Contract #: 04-0120F4Cty: SF/ALA Rte: 80 PM: 13.2/13.9File #: 69.25B**QUALITY ASSURANCE -- NON-CONFORMANCE REPORT****Location:** Changxing Island, Shanghai, PRC**Report No:** NCR-000221**Prime Contractor:** American Bridge/Fluor Enterprises, a JV**Date:** 02-Dec-2008**Submitting Contractor:** Zhenhua Port Machinery Company, Ltd (ZPMC), Changxing Island**NCR #:** ZPMC-0197**Type of problem:**

**Reference Description:** DP-598-001 and DP-612-001**Description of Non-Conformance:**

**Subject:** NCR No. ZPMC-0197

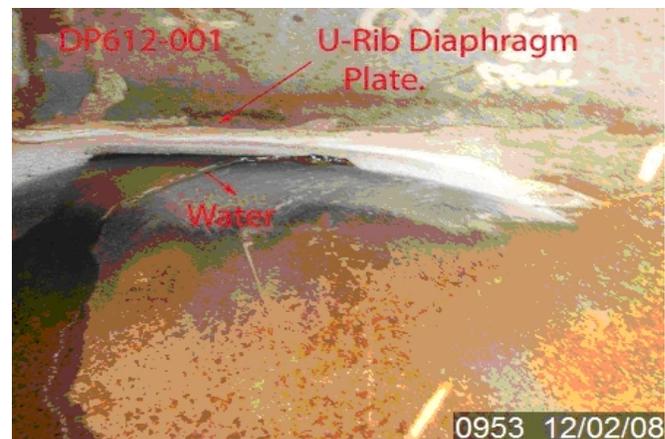
The Quality Assurance Inspector observed rust at the location of a closed rib open-root repair (indicating that water had been present; 1st photo). Subsequently QA Inspector, observed ZPMC personnel remove sealant caulking (by grinding) on several, deck panel to u-rib diaphragm plates on deck panels DP598-001 and DP612-001. The caulking between u-rib diaphragm plates and deck panel was removed in an effort to relieve entrapped water located within the deck panel u-rib. The Quality Assurance Inspector observed water pour through the location where caulking was removed. The presence of water inside these deck panels is not in conformance with the State of California Department of Transportation Standard Specifications.
